BCSC LF Smith Elementary & Columbus East High School

Bid Package #1

Addendum #4

February 13, 2025

DRAWING NO.: SK201B

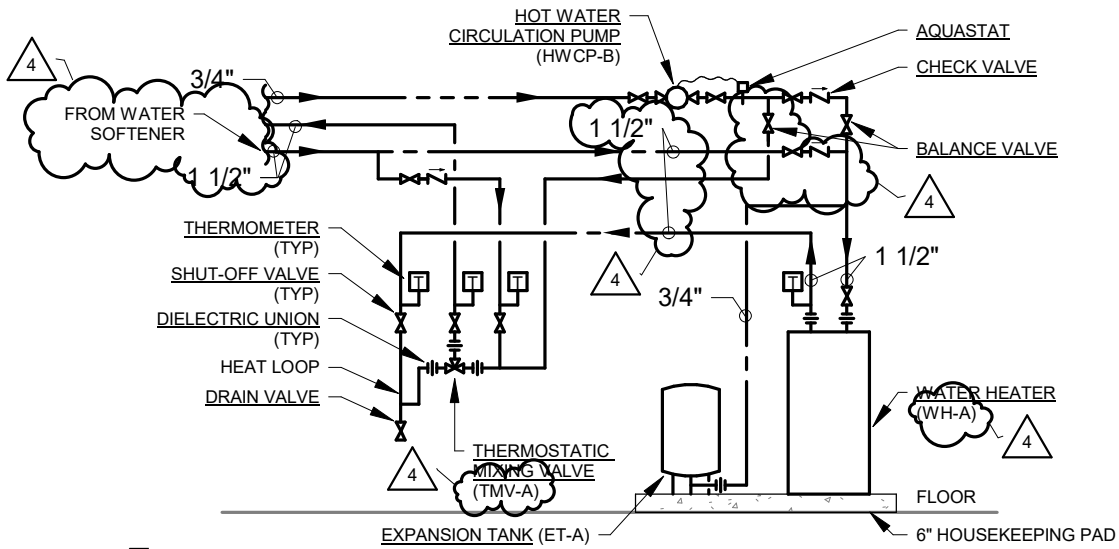
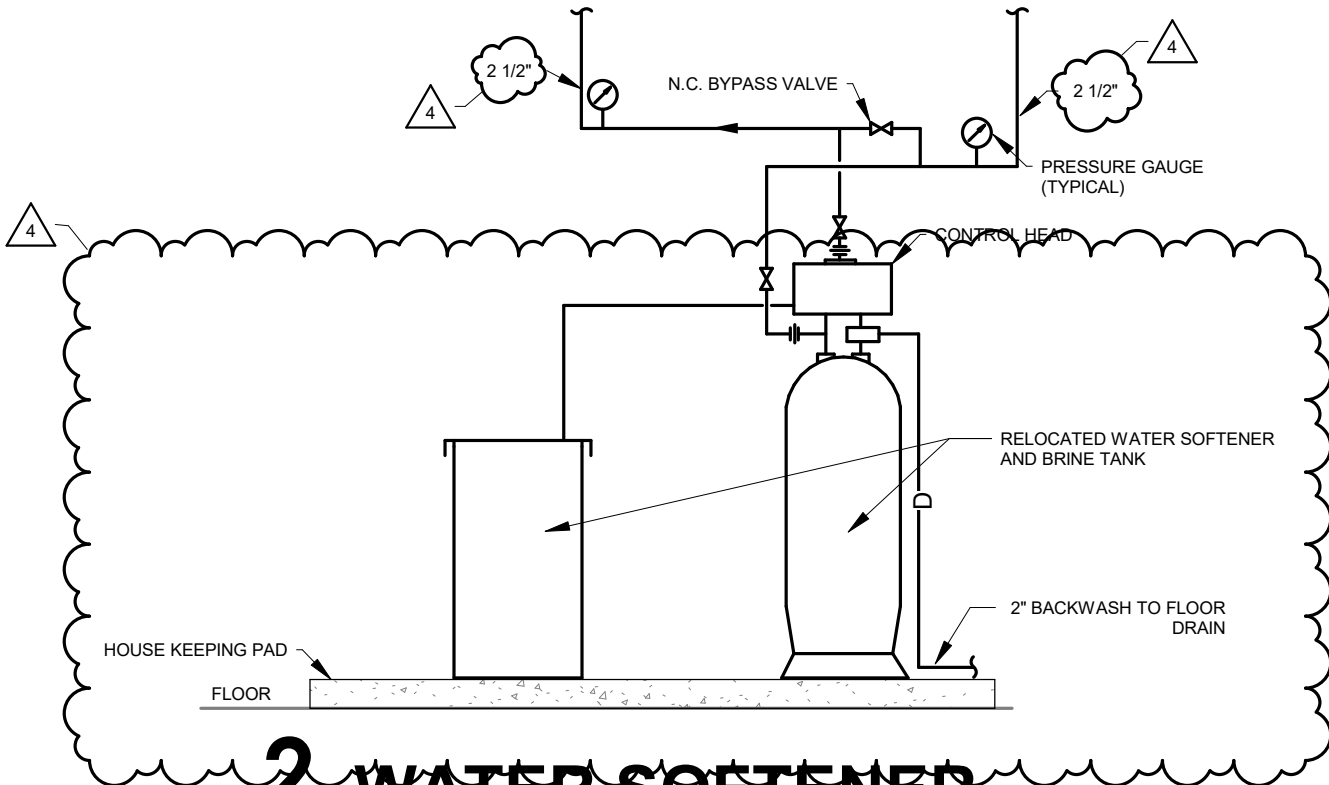
- A. Revise the mechanical room piping, see attached sketch SK201B
- B. Add relocated water softener and other plumbing equipment, see attached sketch SK201B
